ST. TAMMANY PARISH

Addendum No.: 1

Bid#: 24-43-2

Project Name: Brewster Road Sewer Consolidation

SHEET NO.
20PP-04

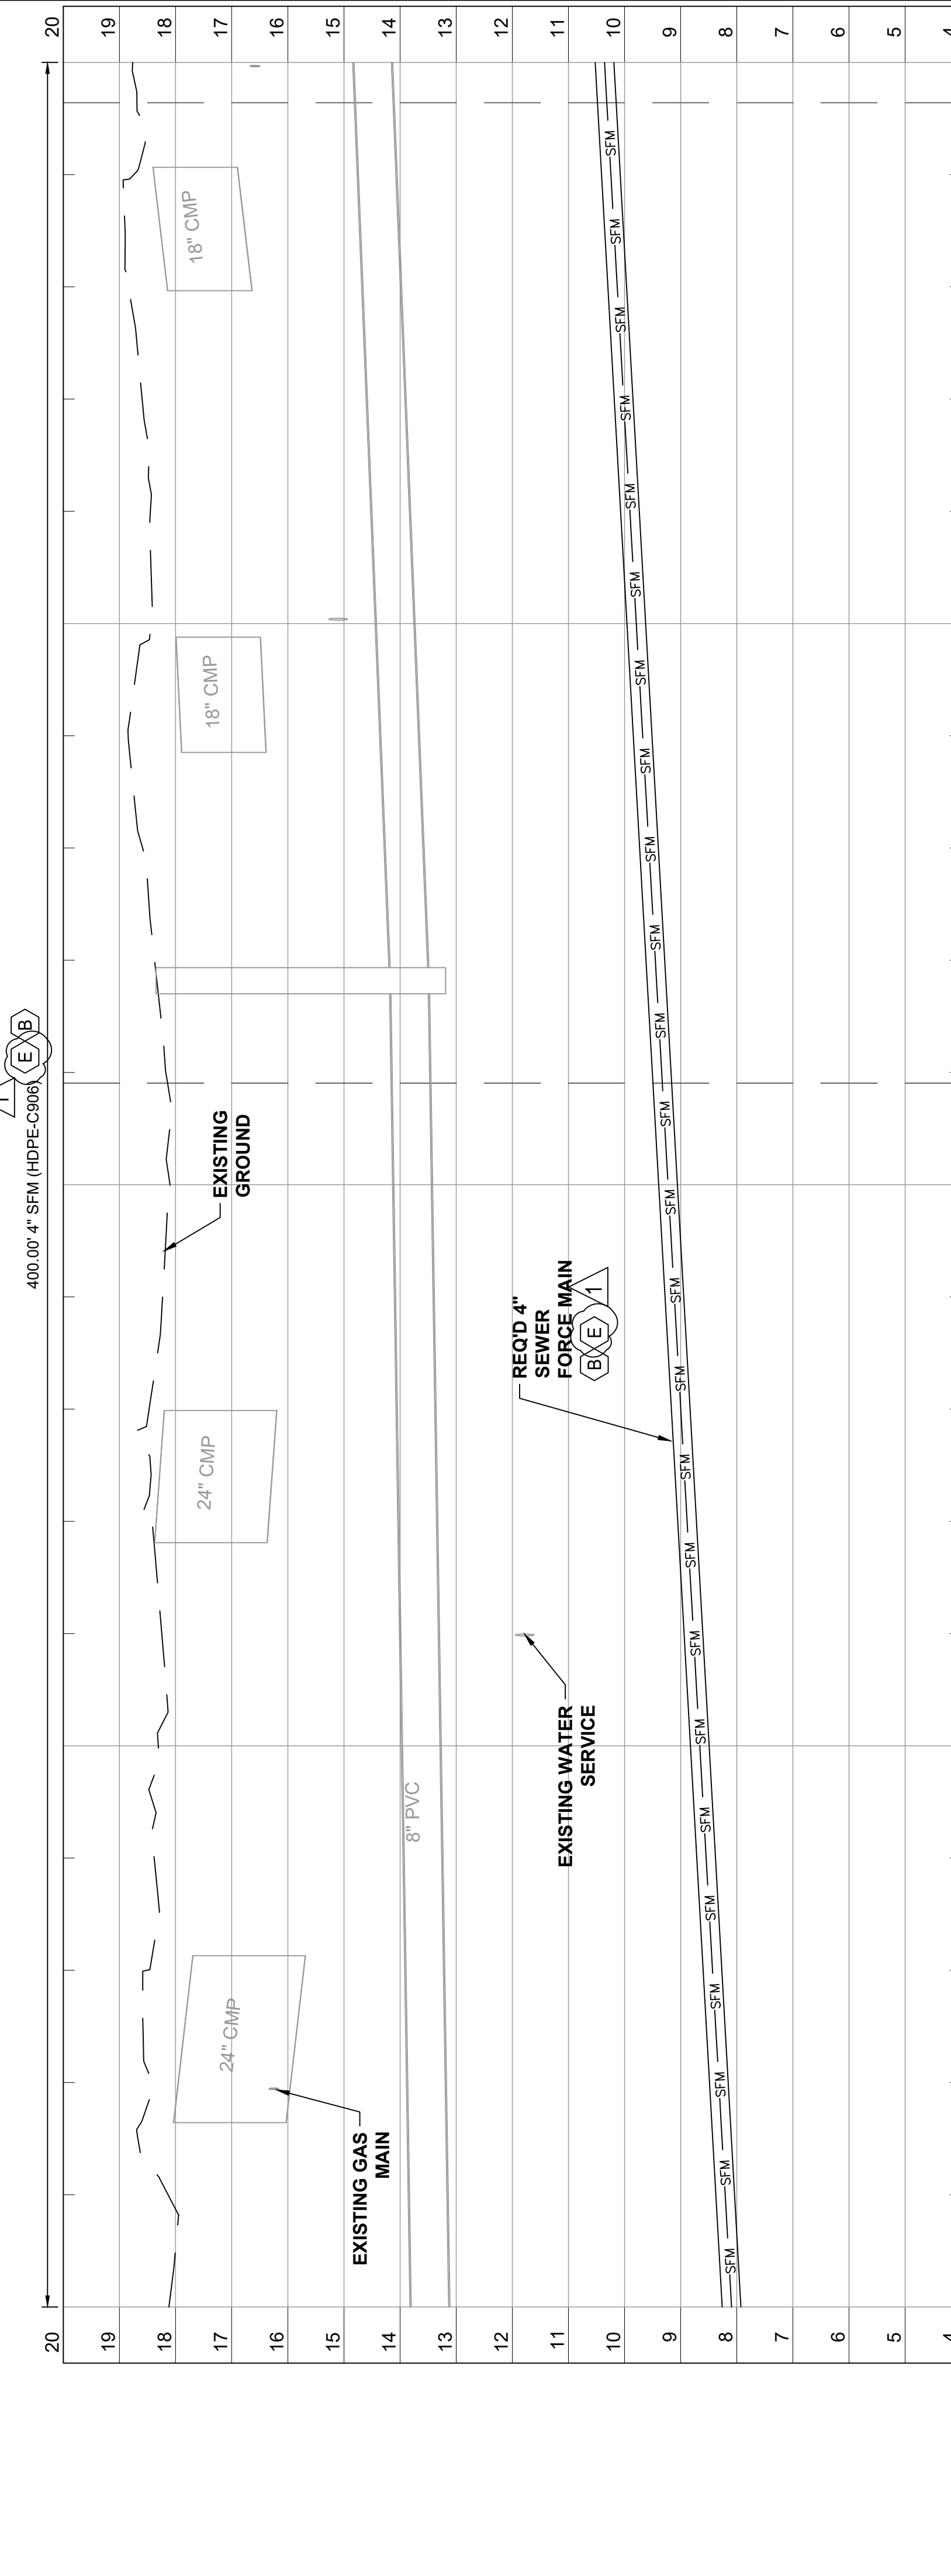
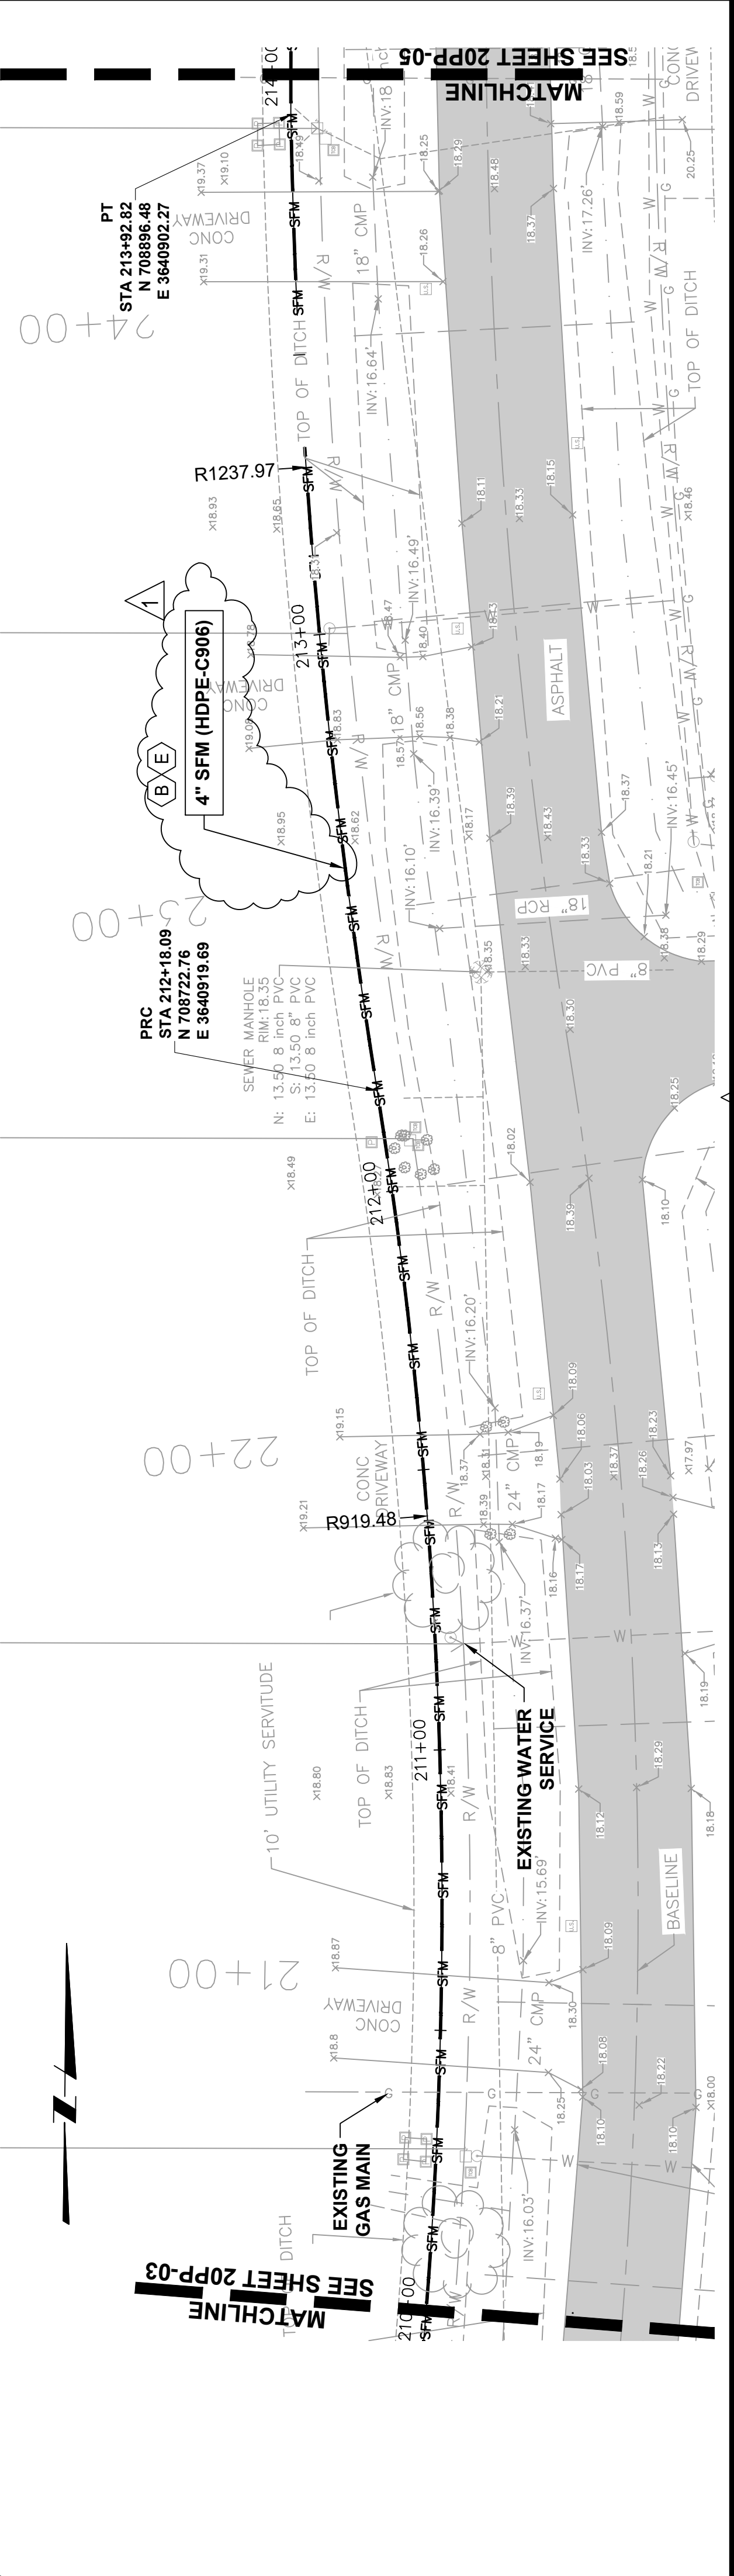
- e. DELETE Drawing 20PP-02 and REPLACE with the attached REVISED Drawing 20PP-02.
- f. DELETE Drawing 20PP-03 and REPLACE with the attached REVISED Drawing 20PP-03.
- g. DELETE Drawing 20PP-04 and REPLACE with the attached REVISED Drawing 20PP-04.
- h. DELETE Drawing 20PP-05 and REPLACE with the attached REVISED Drawing 20PP-05.
- i. DELETE Drawing 30-03 and REPLACE with the attached REVISED Drawing 30PP-03.
- j. DELETE Drawing 40PP-02 and REPLACE with the attached REVISED Drawing 40PP-02.
- k. DELETE Drawing 40PP-03 and REPLACE with the attached REVISED Drawing 40PP-03.
- l. DELETE Drawing 40E-02 and REPLACE with the attached REVISED Drawing 40E-02.
- m. DELETE Drawing 40E-04 and REPLACE with the attached REVISED Drawing 40E-04.

SHEET NO.
40E-02

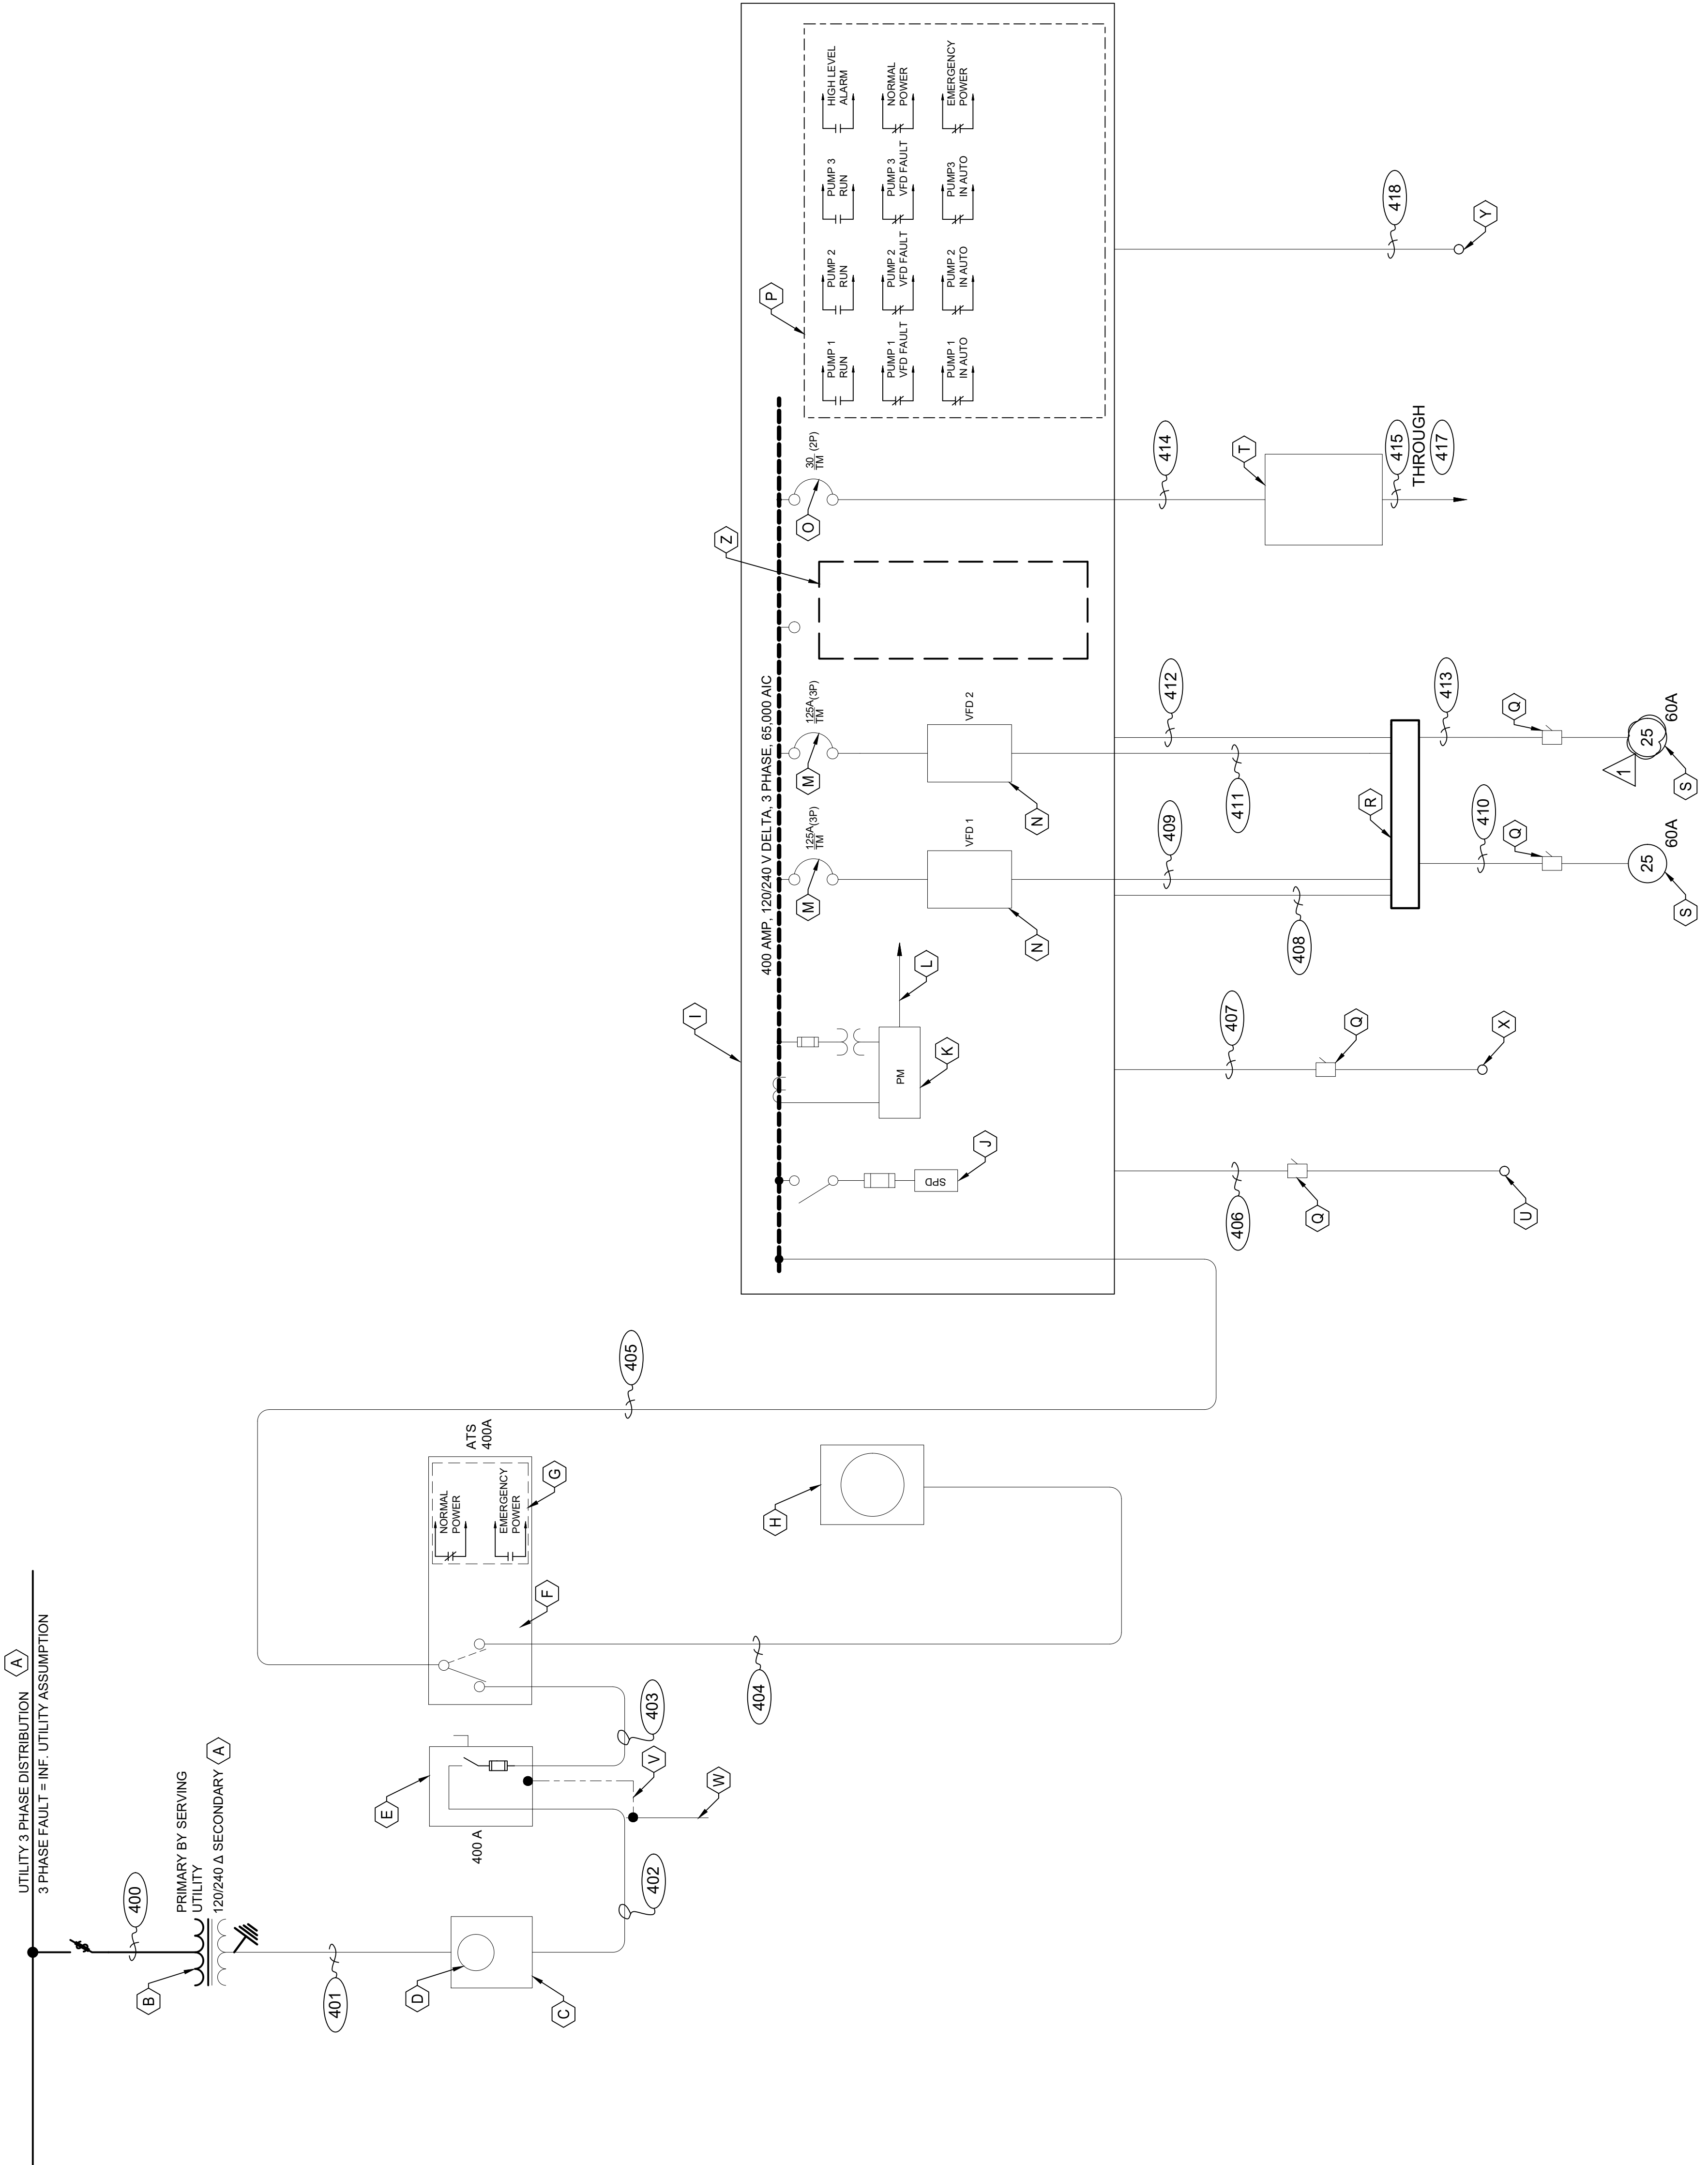
5. REVISED Section 01 29 00 – Measurement and Payment.
6. REVISED Section 01 45 00 – Quality Control.
7. REVISED Section 09 96 00 – Protective Coatings.
8. REVISED Section 31 05 16 – Aggregates.
9. REVISED Section 31 30 00 – Earthwork.
10. Section 40 91 02 – Variable Frequency Drive Control Panel.
11. Section 40 91 04 – Motor Starter Control Panel.
12. REVISED Section 43 25 06 – Submersible Solids Handling Pumps.
13. REVISED Drawing 10PP-05.
14. REVISED Drawing 10PP-06.
15. REVISED Drawing 10PP-07.
16. REVISED Drawing 10PP-09.
17. REVISED Drawing 20PP-02.
18. REVISED Drawing 20PP-03.
19. REVISED Drawing 20PP-04.
20. REVISED Drawing 20PP-05.
21. REVISED Drawing 30PP-03.
22. REVISED Drawing 40PP-02.
23. REVISED Drawing 40PP-03.
24. REVISED Drawing 40E-02.
